**REVISED MONITORING AND REPORTING
PROGRAM NO. R6V-2007-(PROPOSED)**

**PACIFIC GAS AND ELECTRIC COMPANY
REVISED CENTRAL AREA IN-SITU
REMEDATION PILOT STUDY PROJECT**

Subject: Comments on Tentative Revised Waste Discharge Requirements for the Central Area In Situ Remediation Pilot Study Project

RESPONSE TO PG&E COMMENTS ON TENTATIVE WASTE DISCHARGE REQUIREMENTS FOR THE REVISED CENTRAL AREA IN-SITU REMEDIATION PILOT STUDY, PG&E COMPRESSOR STATION, HINKLEY, SAN BERNADINO COUNTY

**Well Layout
Revised Central Area In Situ
Remediation Project**

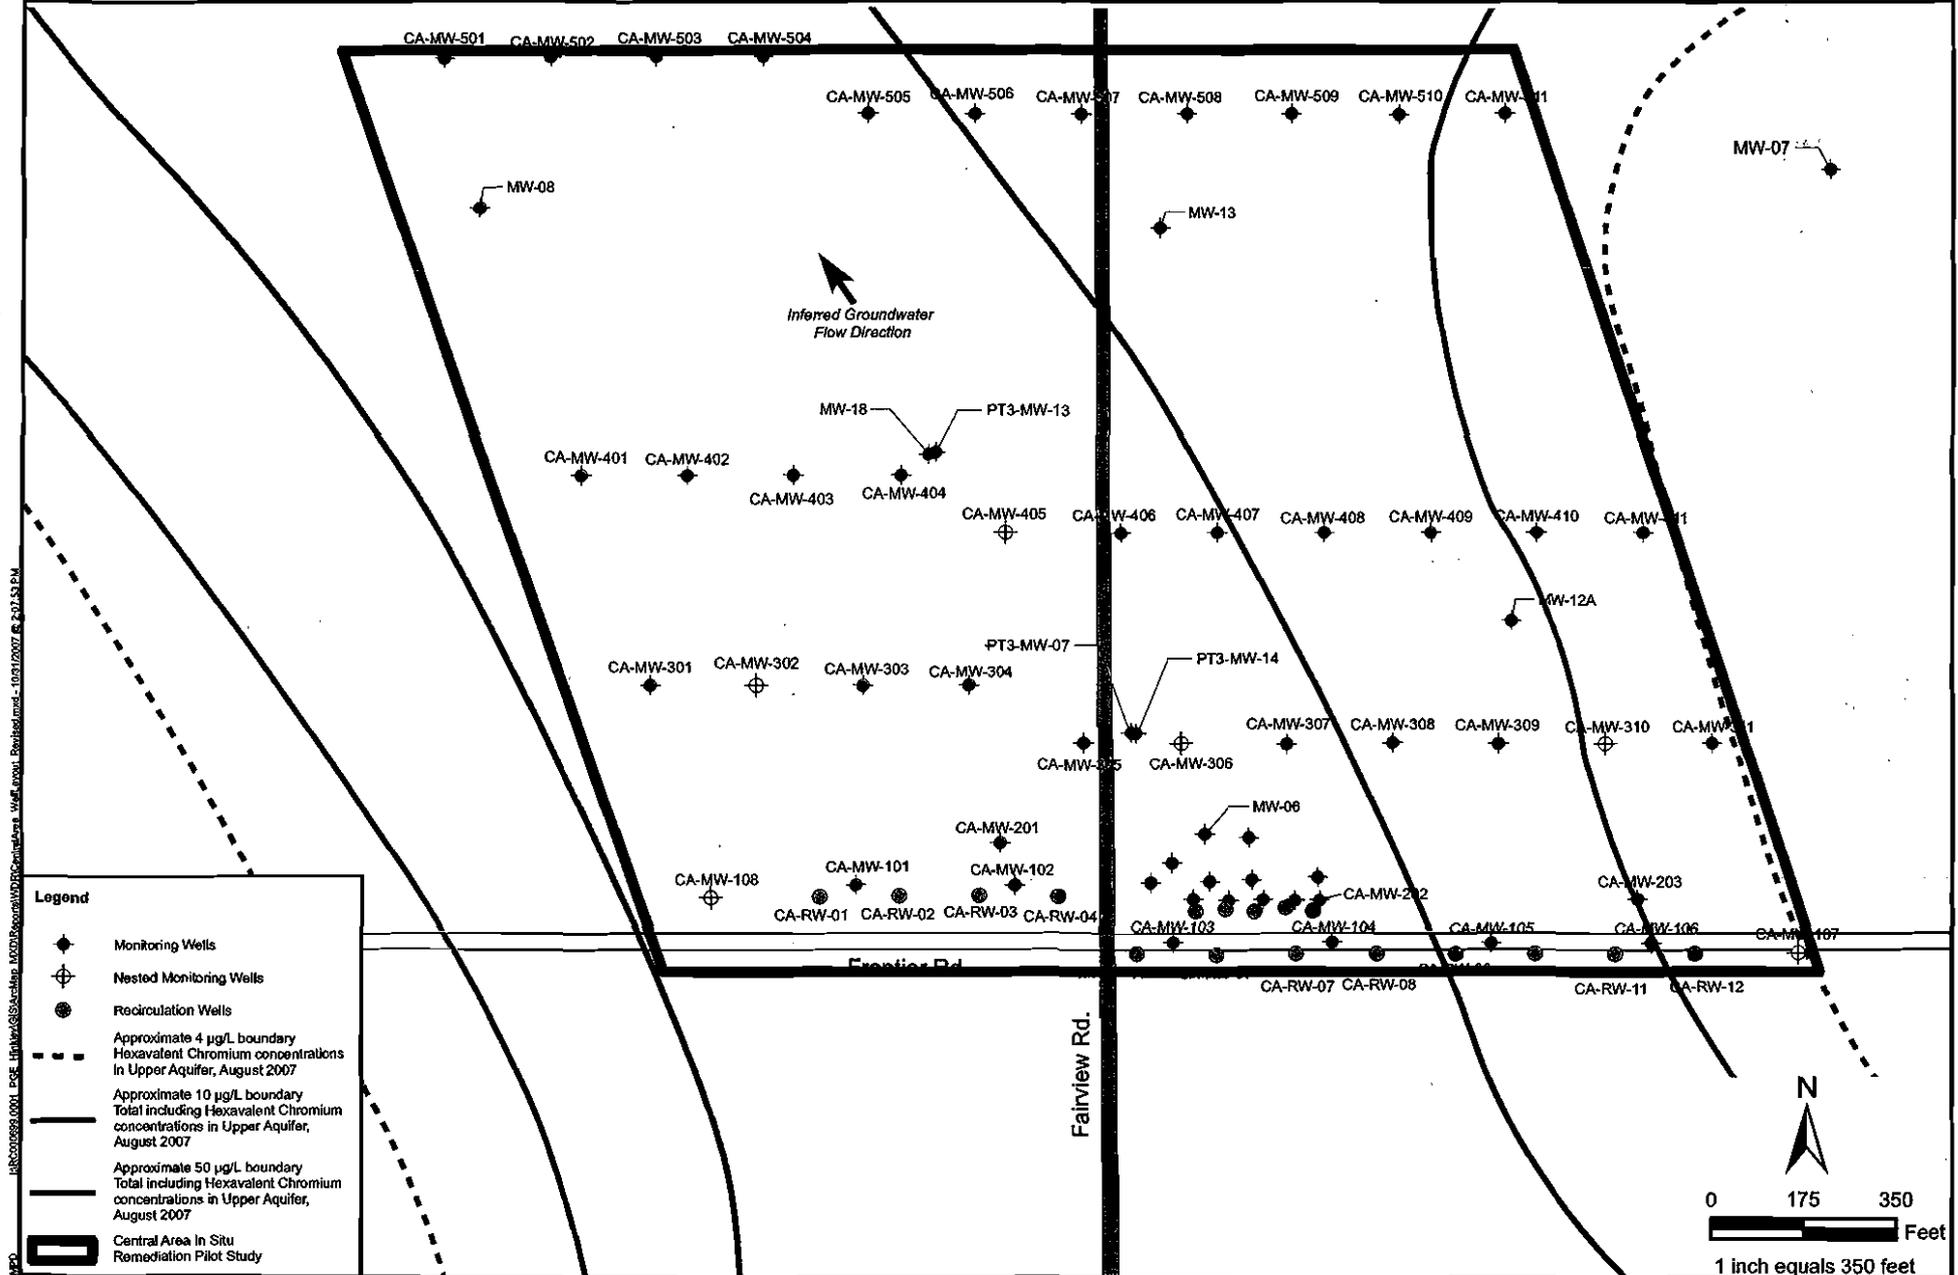
18. **Page 1, Table 1.** Nested wells were located in the Central Area as listed in Table 1 of the tentative revised WDRs where possible. However, in some instances the lower permeable unit did not exist at the ends of the rows of wells. In those cases, nested wells were constructed at the location closest to the end of the row that did have two permeable units. To clarify this in the text, the well IDs should be included in the nested well location description in Table 1 as follows:

- 1) At each end of the injection well line (CA-MW-107 and CA-MW-108).
 - 2) In the first row of sentry wells (CA-MW-302, CA-MW-306, and CA-MW-310).
 - 3) In the second row of sentry wells (CA-MW-405).

Response: Water Board staff acknowledges the Discharger's attempts to install nested monitoring wells at locations specified in the tentative WDR. We agree that the nested wells installed at alternate and nearby locations will be able to meet the intent of the monitoring requirement. Therefore, the proposed M&R will cite the monitoring well numbers and list the alternate locations.

**Well Layout
Revised Central Area In Situ
Remediation Project**

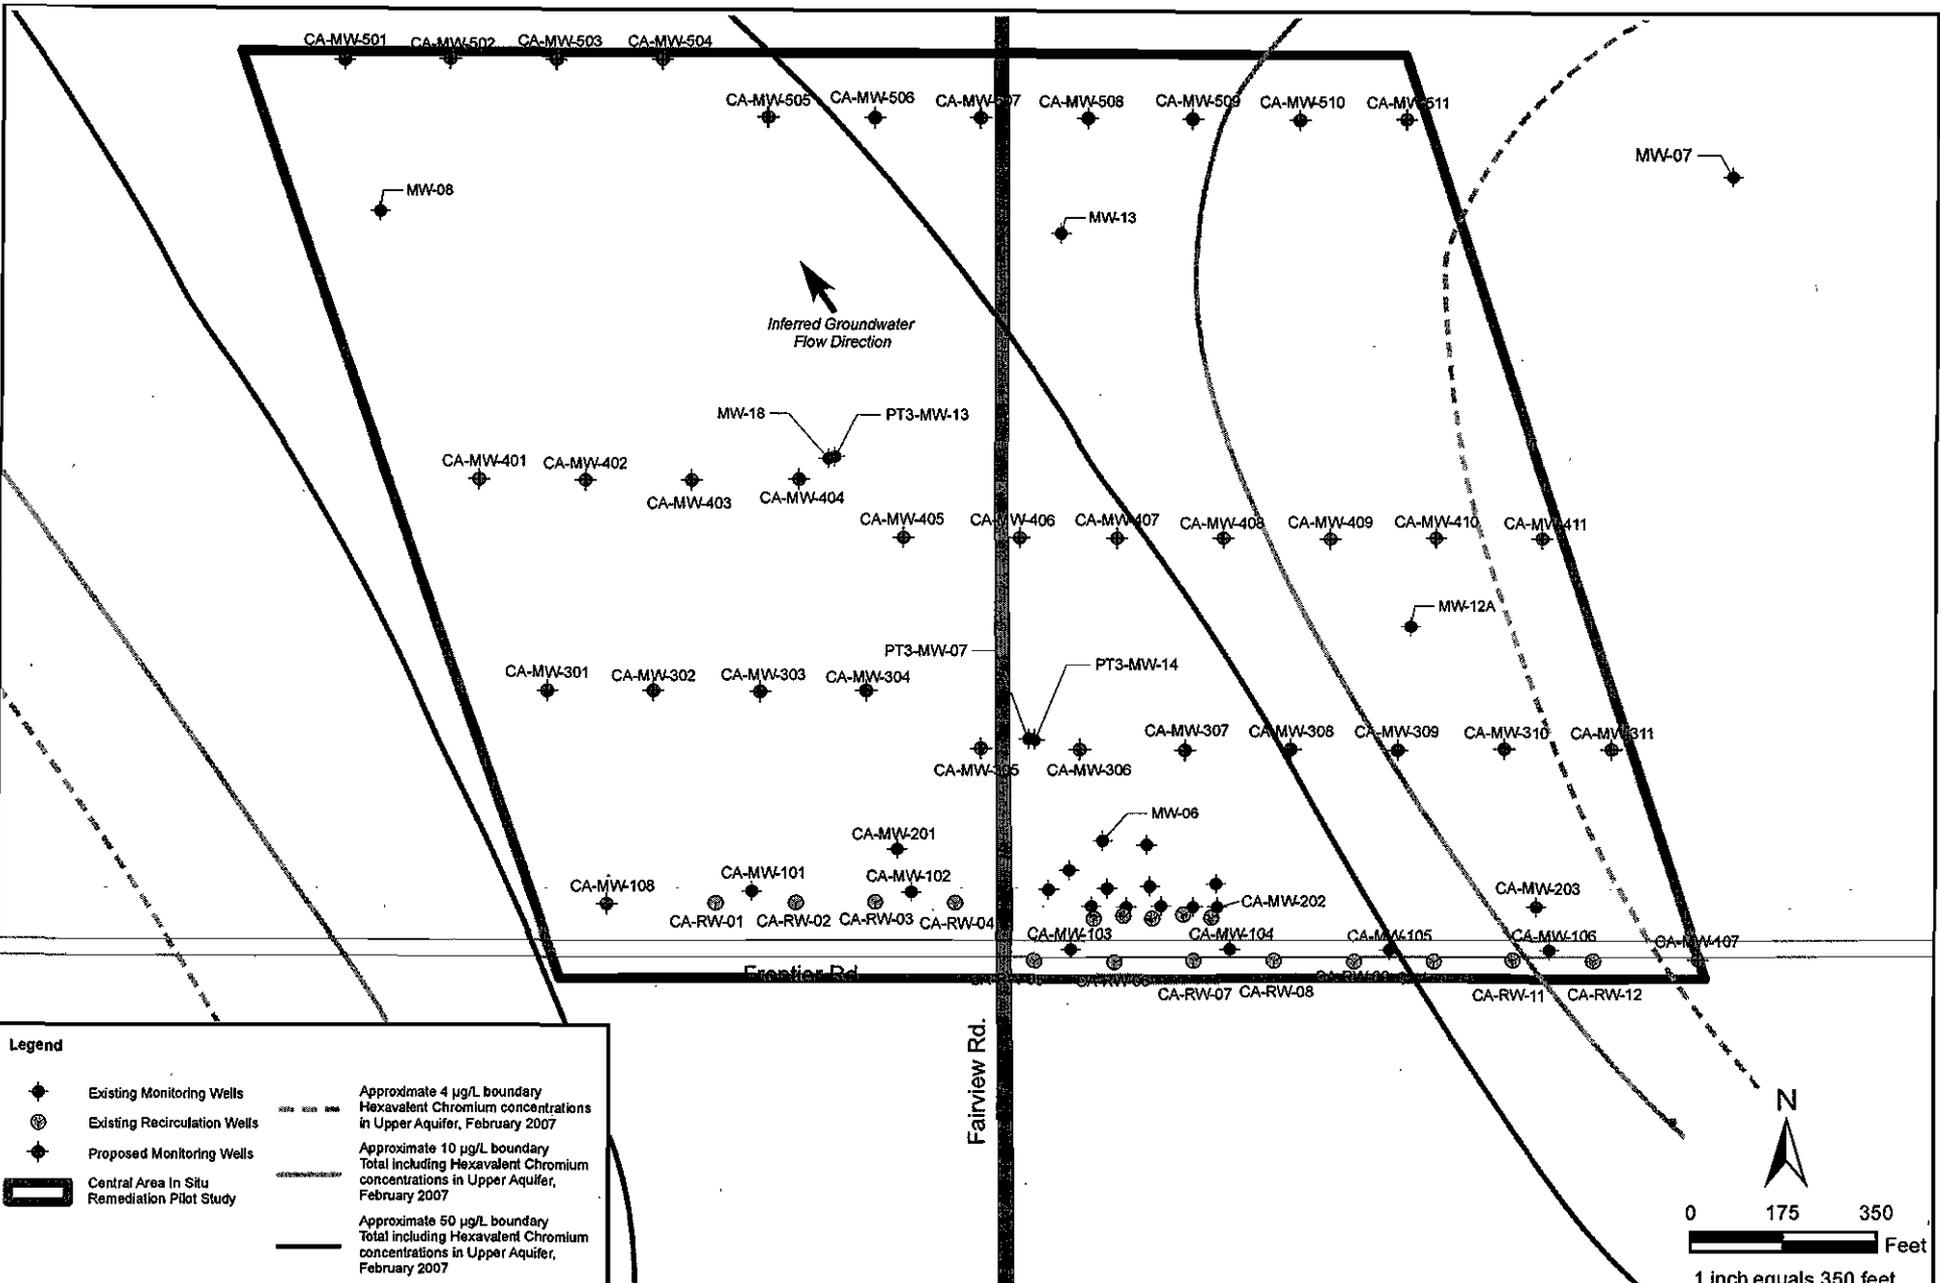
15. **Page 10, Concentration and Reporting Limits Table.** The note on the dissolved manganese concentration should be changed to, "Concentration limit to be set at 125 percent of the maximum background concentration measured in groundwater prior to the initial injection of reagents."
16. **Page 11, Section I.D.6.** This section should be removed as it appears to be a vestige of an earlier draft.
17. **Attachments A and B.** Updated Attachments A and B for the revised WDRs are attached to this letter. Please replace the Attachments in the tentative revised WDRs with these figures.

7. Comment No. 18 (Page 1, Table 1, M&R): States that Discharger's attempts to install some nested monitoring wells at locations specified in the tentative WDR were not possible due to local geology. Suggests language that some nested well were installed at alternate locations that are nearby to the locations listed in the tentative WDR. These alternate locations are still able to meet the monitoring intent for conducting multi-depth sampling within the Upper Aquifer.
